COMMENTS FROM INDIVIDUALS

Received prior to the 48 hour rule deadline of August 2, 2016 at 1 pm

Re: Official EPC Comments on the ABC Comprehensive Plan with emphasis on proposed zoning in the Integrated Development Ordinance

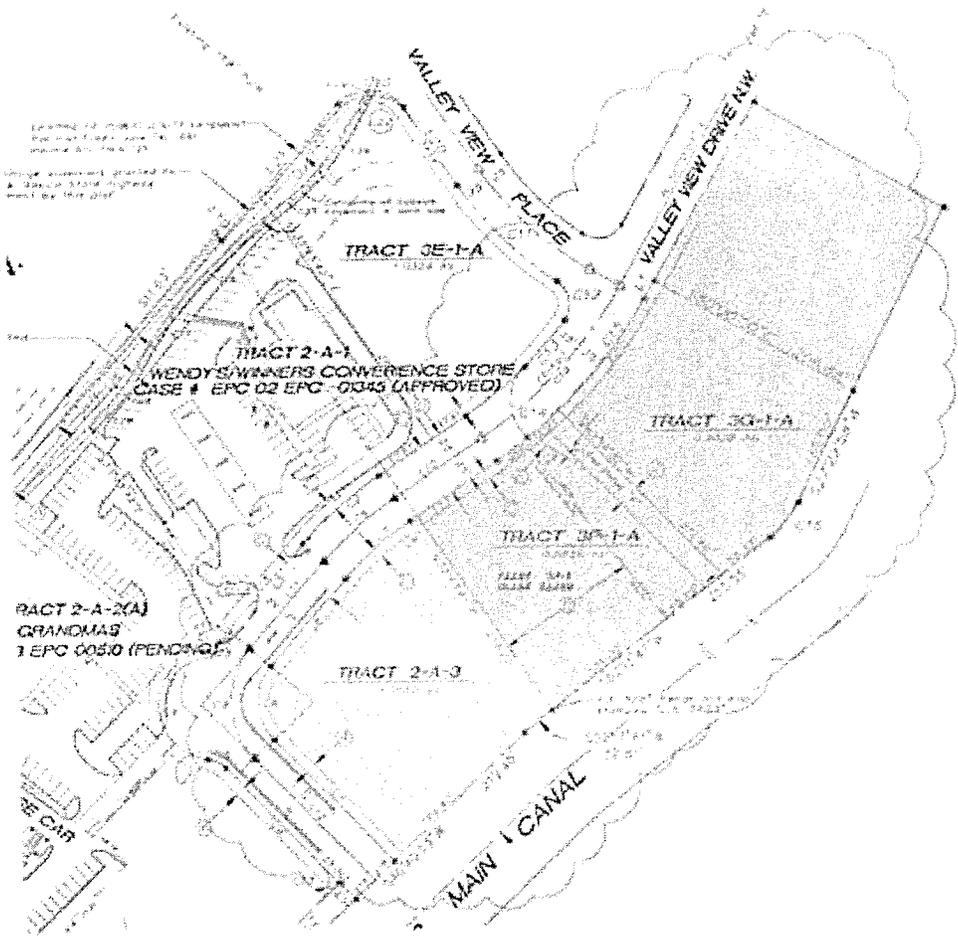
Tract 2-A-3 The parcel in YELLOW below is zoned SU-1 for C-1 (Neighborhood Commercial) Permissive Uses & Hotel not to Exceed 2 Stories & Restaurant w/ Full Service Liquor. This parcel would allow for a "Green Jeans" concept with restaurant, brewery, retail sales, services, etc. all permissive with the exclusion of a drive up restaurant which is Conditional. This parcel is part of the Amended Site Plan for Subdivisions Tract 2 A approval and is subsequently governed by the design standards in place. The standards allow for a height of up to 32 ft. as long as the view corridor restrictions of the Coors Corridor Plan are met.

Tract 3F-1-A, Tract 3G-1-A, Tract 3H – All of these parcels in BLUE plus the adjacent Tracts 3I and 3J in the Black Ranch Subdivision are zoned straight O-1 (Office and Institutional). These parcels would allow as a CONDITIONAL USE the Retailing of food and drink, for consumption on premises or off, but not drive-in facility and provided that alcoholic drink is not dispensed for off-premise consumption in broken packages or the following packages within 500 feet of a pre-elementary, elementary or secondary school, a religious institution, a residential zone, a designated Metropolitan Redevelopment Area (as defined in the State Metropolitan Redevelopment Code), a city owned park or city owned major public open space:

BLACK RANCH SUBDIVISION COMMERCIAL LAND EAST OF NORTH COORS BLVD.

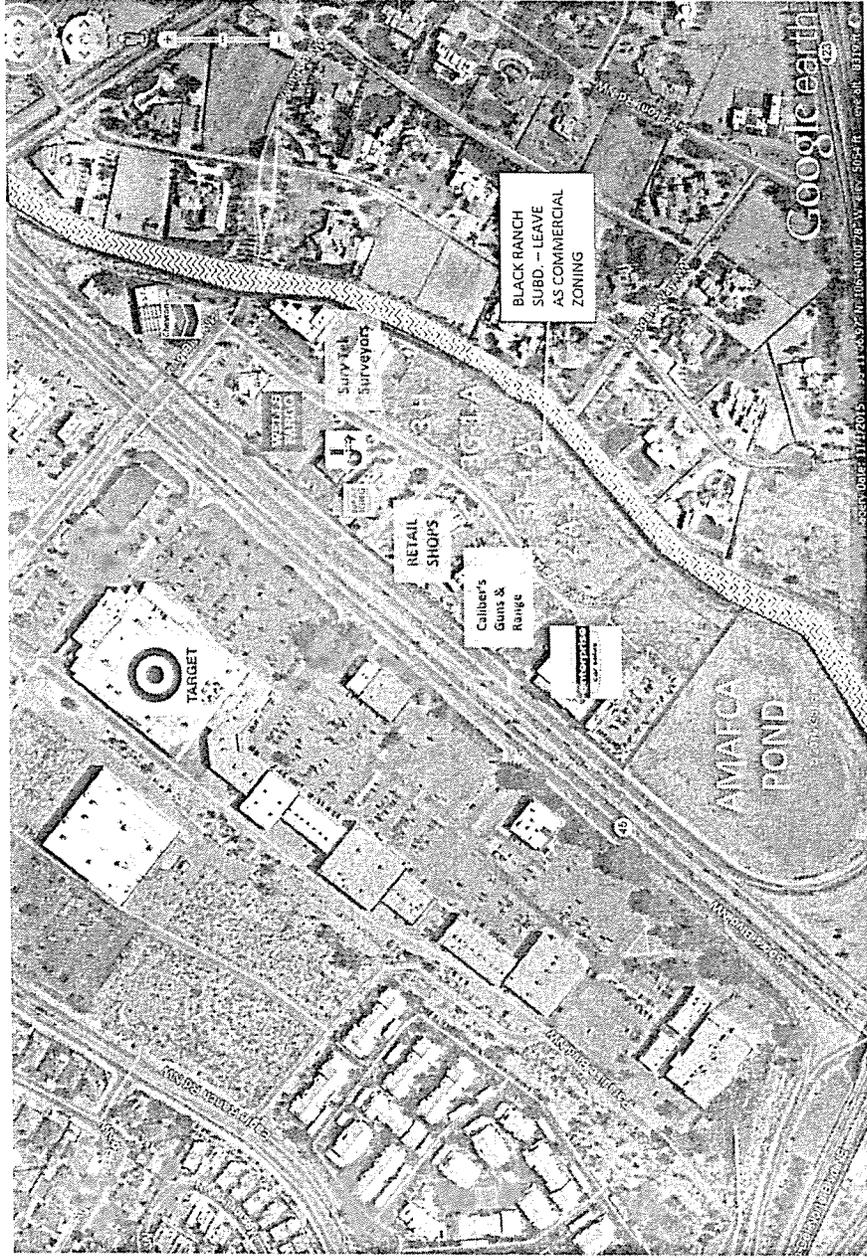
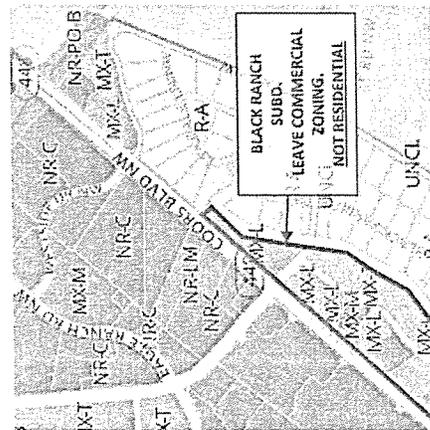
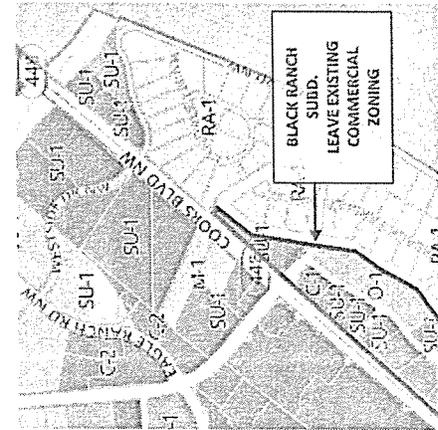
There appears to be some errors in the new IDO Rezoning Plan in terms of the commercial developments along the east side of North Coors Blvd between Paseo del Norte river crossing north to Alameda Blvd. (please see attached PDF).

I had met with the City planners on this matter before but I see know changes to reflect the existing commercial zoning we have in place. I am not sure what "MX L and MX T" but the brown and tan colors shown on these properties in your new plan appear to be some kind of residential zoning, not the existing commercial zoning we have. The subdivisions I am referencing in my attached PDF which shows the IDO proposed zoning and the existing zoning as well as aerial photos showing the existing developments in these subdivisions and the immediately surround areas. There are a lot of commercial buildings already built in these subdivisions and I am sure they will not accept the downzoning of their properties to a residential zoning, either. We want to cooperate with the City on the simplification of our zoning codes, but we are not cooperating on a down zoning of our properties.

Look at the aerial photos supplied in my PDF and you will see a lot of existing commercial businesses and the few commercially zoned and developed vacant lots in between these existing businesses. These properties have been non-residentially zoned since the 1980's through the early 2000's. They are owned by myself and other people I sold the lots to several years ago at commercial prices. The commercial zoning for these lots were approved by the City and the adjacent neighborhoods. The new IDO Rezoning Plan appears to downzone even the existing businesses as well as the few remaining vacant commercial lots in these subdivisions. This downzoning is not acceptable nor appropriate for these properties. A lot of the existing property owners are not even aware of the current proposed zoning changes. Non-residential commercial zoning is the only appropriate zoning for all of these lots.

We request in the new IDO Rezoning Plan a zoning that is a “non-residential” commercial zoning that is at least as good as the existing zoning we have on these properties. I know the City is trying to clean up the old SU-zoning and replace it with straight zoning which we applaud, but we cannot tolerate a down zone on our properties in this new plan.
